# SYDNEY WEST CENTRAL PLANNING PANEL

Panel Reference	JRPP No. 2016SYW238		
Number			
DA Number	DA 2016/392		
Local Government Area	Cumberland		
Proposed Development	Consolidation of 5 lots into 1 lot, part demolition of existing structures, new access driveway off Belinda Place, construction of a part 2, part 3 storey community facility over 3 levels of basement car parking accommodating 197 parking spaces, a dining hall and an auditorium (meeting hall) accommodating a maximum of 800 patrons, multi purpose halls to be used in association with an existing place of public worship.		
Street Address	217 Great Western Highway and 3 – 9 Belinda Place, Mays Hill		
Applicant/Owner	The Saiva Manram		
Number of Submissions	Three (3)		
Regional Development Criteria (Schedule 4A of the Act)	Capital Investment Value \$15,688,915.00 (>\$5 million)		
List of All Relevant s79C(1)(a) Matters	<ul> <li>State Environmental Planning Policy No. 55 – Remediation of Land</li> <li>State Environmental Planning Policy (Infrastructure) 2007 (SEPP Infrastructure)</li> <li>Holroyd Local Environmental Plan 2013 (HLEP 2013)</li> <li>Holroyd Development Control Plan 2013 (HDCP 2013)</li> <li>Section 92 of the EP&

Figure 6 – 15m Height Plane Overlay (Source: Roberts Day 2017)

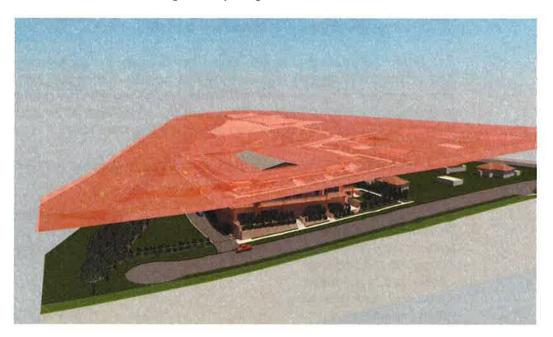
The proposed community facility will provide for a maximum building height RL of 52.29 to the ridge of the proposed gable roof form which equates to a maximum building height of 16.34 metres above the existing ground level at this point.

The proposed building height is varied by up to 1.34 metres, or 8.9%, over the 15 metre limit. It is noted that due to the slope of the subject site, the variation in height will only be 0.76m fronting Belinda Place (to the eastern elevation) and 1.34m to the rear (to the western elevation). The variation arises due to a desire to provide for an elevated gable roof form above the meeting hall on the ground level. This roof form will create internal wall heights for the hall area of 7.5m and an overall internal ridge ceiling height of 10.037m to the proposed pitched gable roof, the pitch of the roof provided at 12°.

The gable roof above the meeting hall is surrounded by flat roof forms to the adjoining main foyer and eastern foyer and to its south where toilet facilities and internal amenity room associated with the use of the building are located. The provision of an elevated roof form surrounded by flat roofs, while having the effect of creating a distinct architectural roof feature for the proposed building will not create any additional floor space.

The extent of the proposed non compliance to the maximum building height is illustrated in the following overlay diagram;
